Area Walk-By Checklist (AWC)

Fermi 2 Seismic Walkdown Guideline
Area Walk-By-Checklist

NJPR-12-0043

(Picture 58)

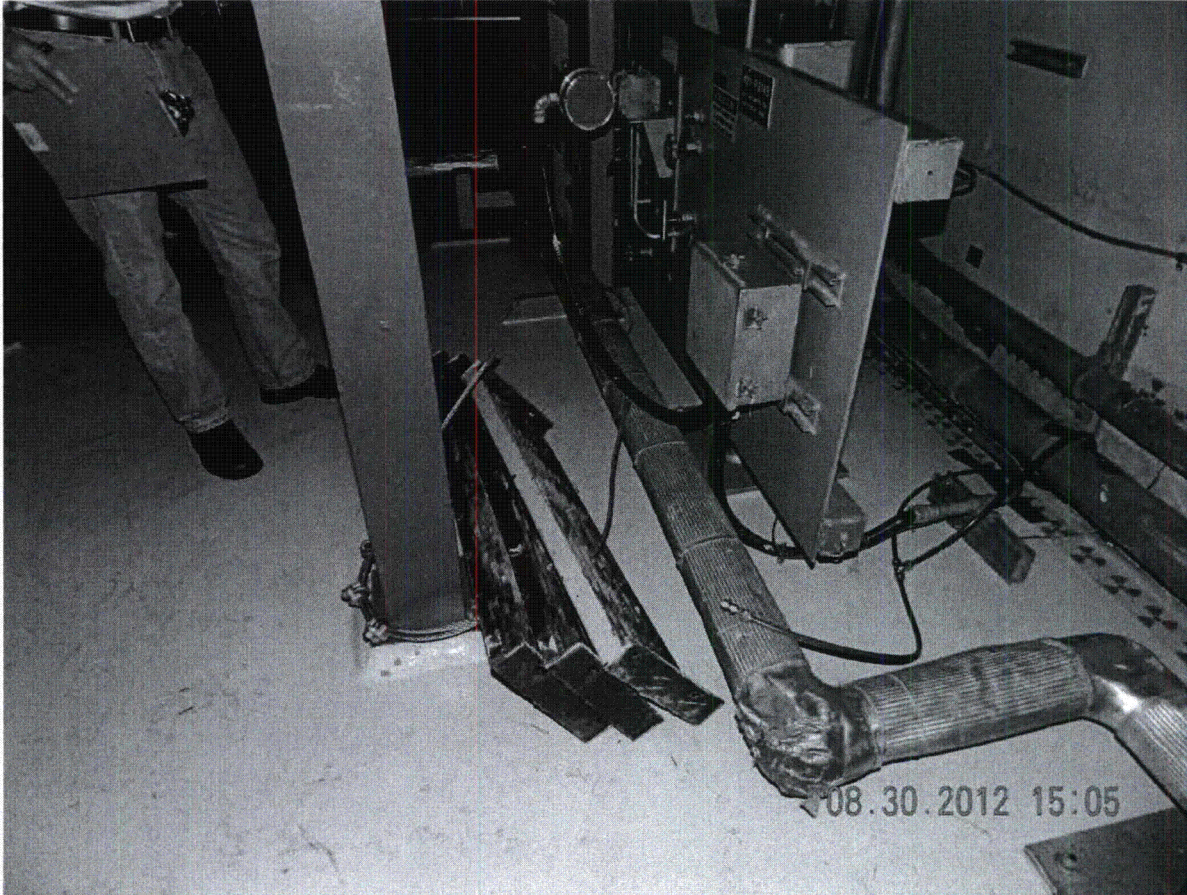
Near the base of the asset, there are some grates that are tied off to a nearby column by a cable. These grates are part of the ISFSI project and will not impact any safety related equipment. The E1102C002B pump casing drain pipe nearby is not safety-related. (See Pictures 58 and 82.)

PICTURE #8

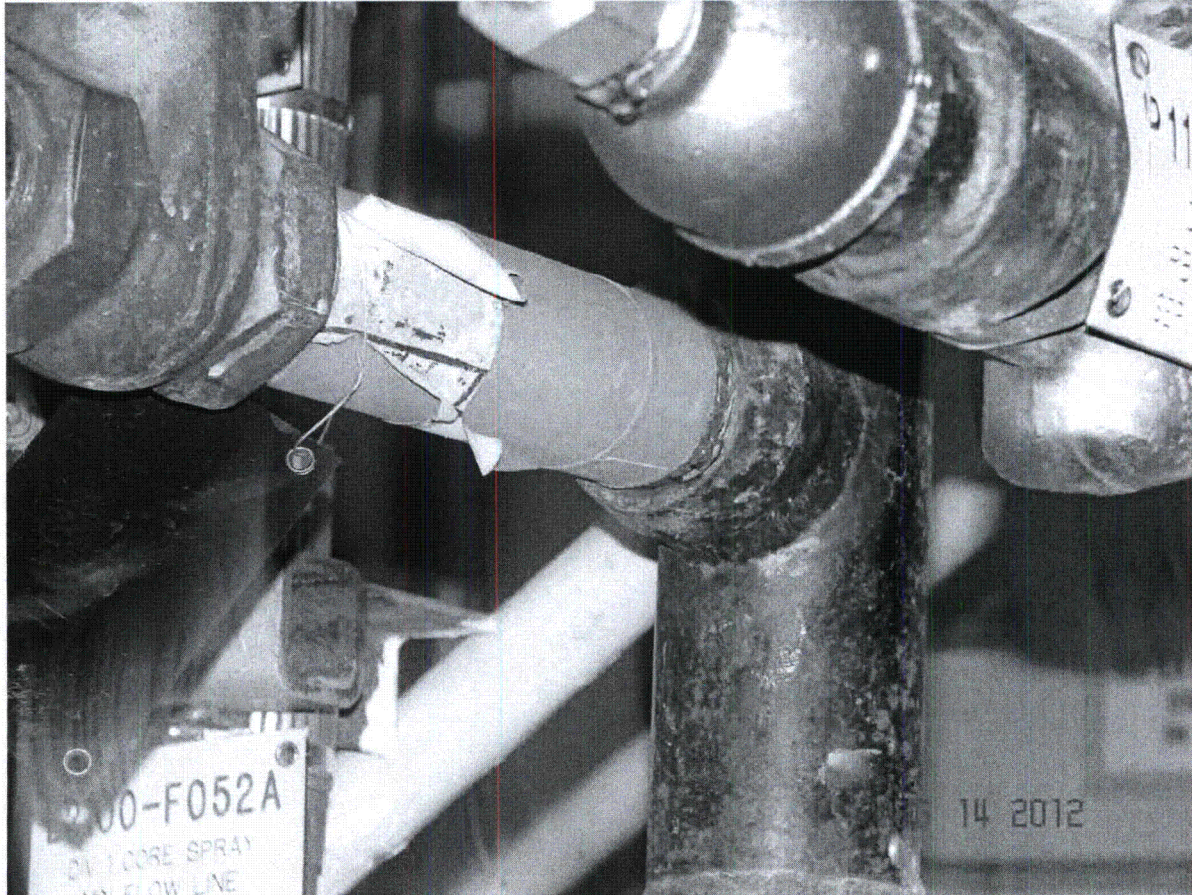
Nearby pipe valve is leaking (P1100F099D). It is not currently a source of potential spray or flooding. (See pictures 8 and 11.) CARD 12-26997 issued for this on 08/21/2012.

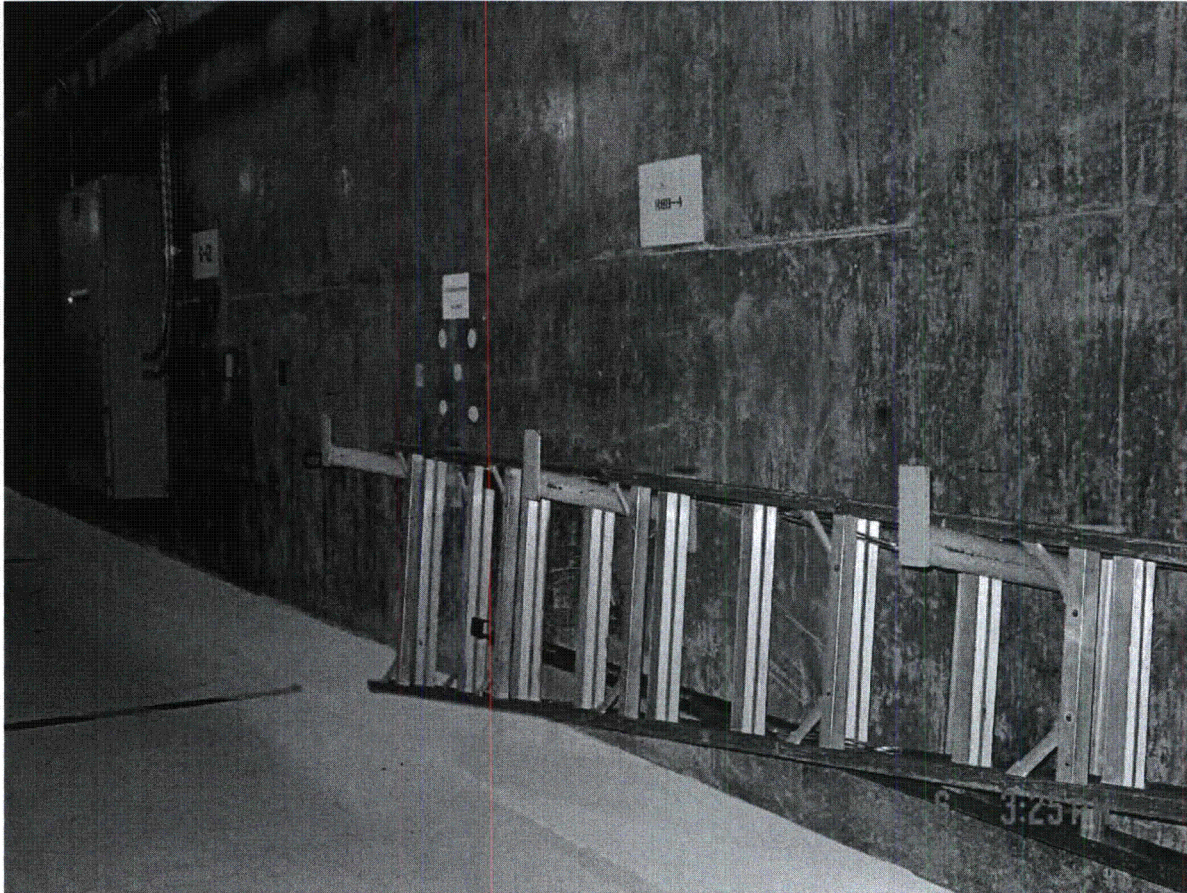
Ladders to the north are not attached by wire to the wall supports. One piece of equipment (PIS 52002D002) to the SE has a vacant anchor hole. The corresponding Division 1 asset has an identical anchor arrangement and our judgment is that anchor is superfluous due to another anchor nearby. Note: Securing of the ladders with a cable is not required on a seismically designed wall mount per Spec. 3071-544 and drawing C-2585. Ok as is.

(See Photo DSC01174 and DSC01178)

(DSC00189)

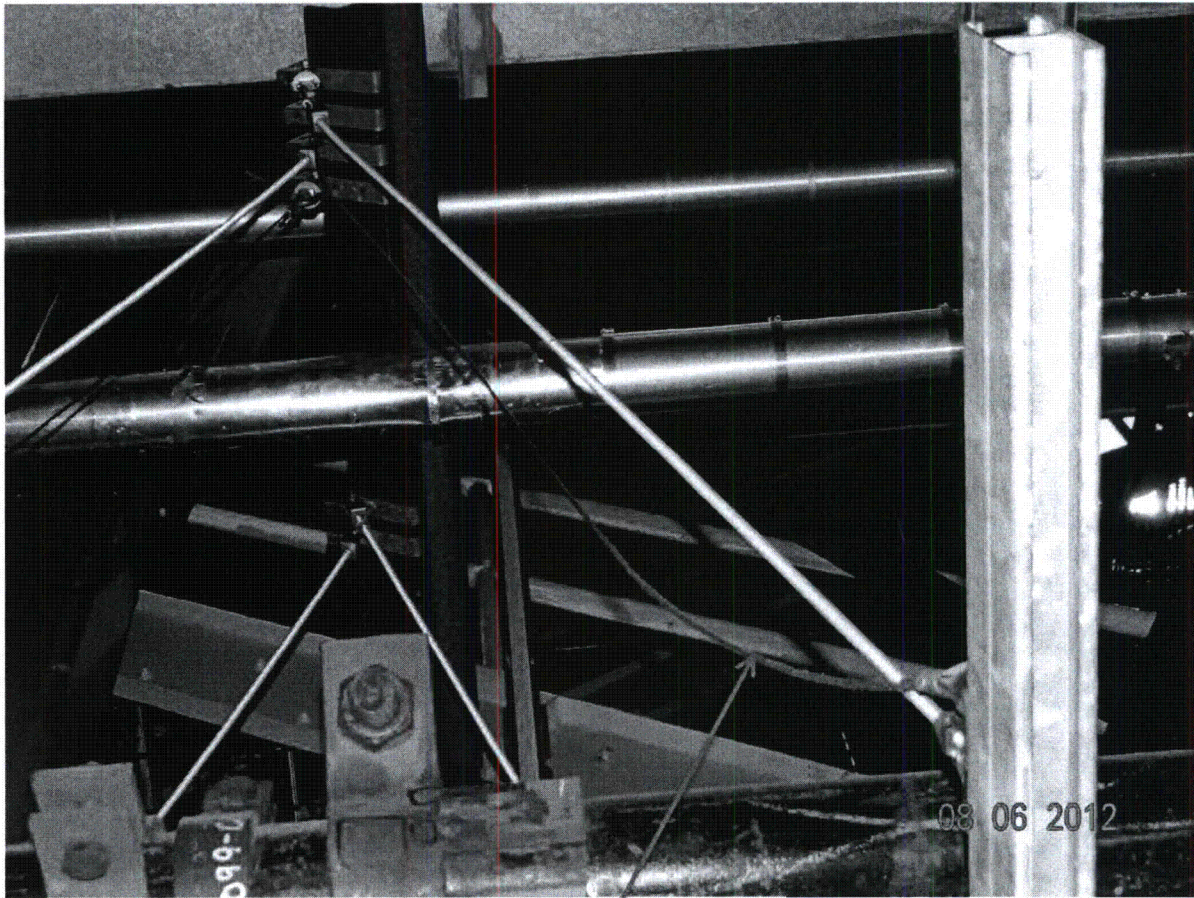
There are no ceiling tiles, with one exception, lighting is well-supported and cannot swing into equipment. See CARD 12-26588 and photos of broken cable that supports lighting on north side of MCC 72E-5A.

Broken cable on support for lighting near MCC 72E-5A was reported on CARD 12-26588 and will be tracked using CARD system as an open item until closed. (See Photos DSC00186 & 189)

(DSC00394)

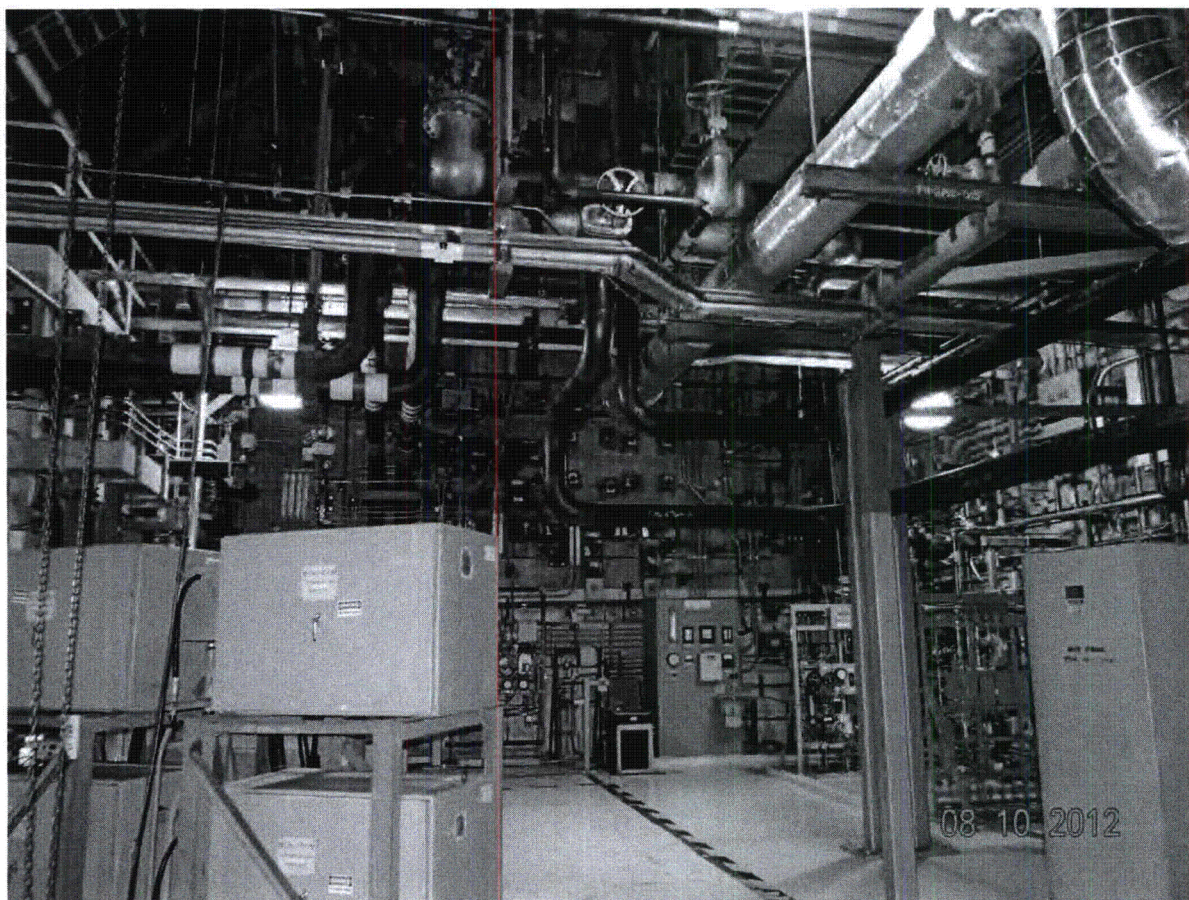
All anchorage appears to be free of potentially adverse conditions. See attached photo of general area DSC 00394.

See attached photo of general area DSC 00394.

(Picture B6)

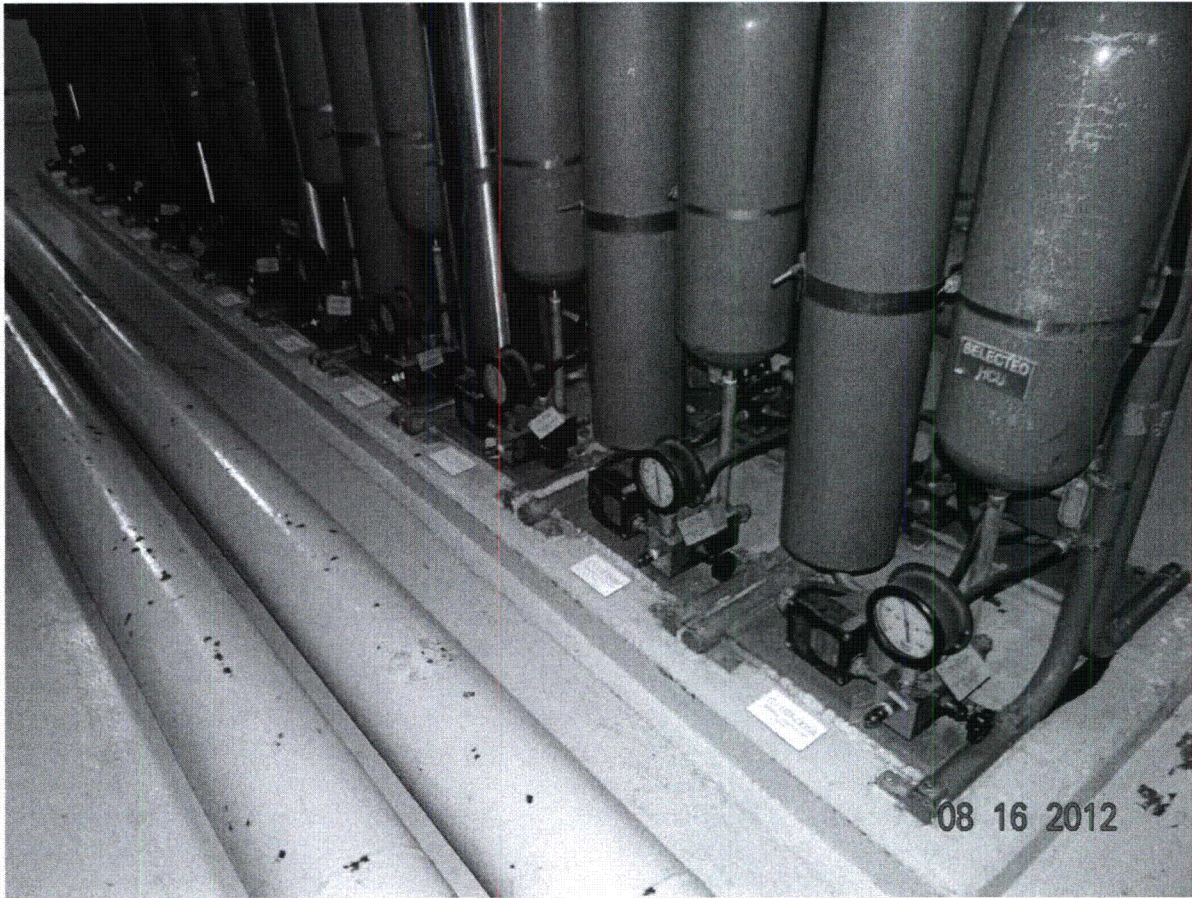
There is some rust in the 2nd anchor on the east side of the north set of the HCU's (C1103D059). This will not affect operability or adversely affect seismic functionality because the anchor is not significantly degraded. (see picture B6)

(Picture 7)

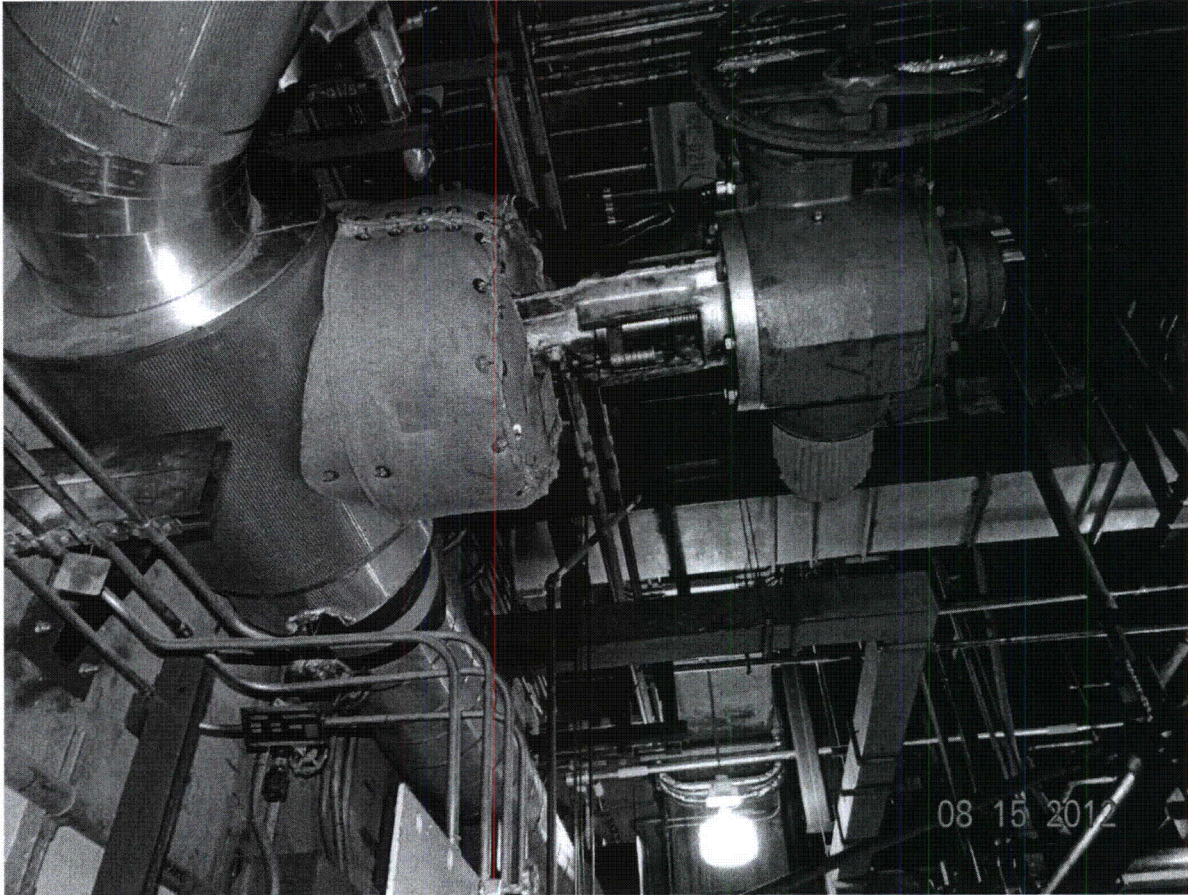
3. Based on a visual inspection from the floor, do the cable/conduit raceways and HVAC ducting appear to be free of potentially adverse seismic conditions (e.g., condition of supports is adequate and fill conditions of cable trays appear to be inside acceptable limits)? Y N U N/A
- There are no observed seismic concerns with any of the nearby cable/conduit raceways or HVAC ducting, including their supports. (See picture 7.)*

(Picture 10)

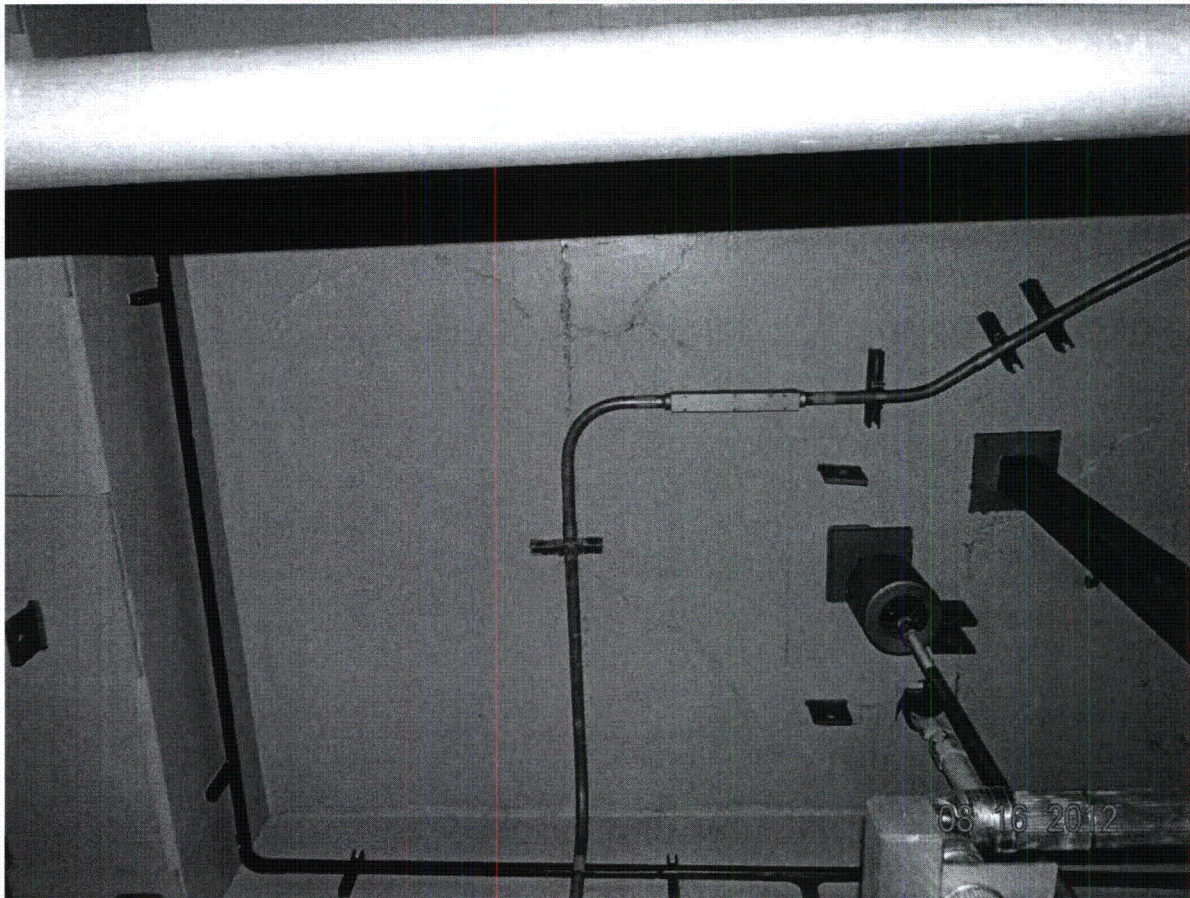
*It was found that there are cracks in the concrete ceiling above the asset. This concern has been forwarded to Engineering for further evaluation (8/23/12)
Engineering has evaluated this concern and has determined that this is an acceptable condition and exists throughout the plant. (8/23/12)*
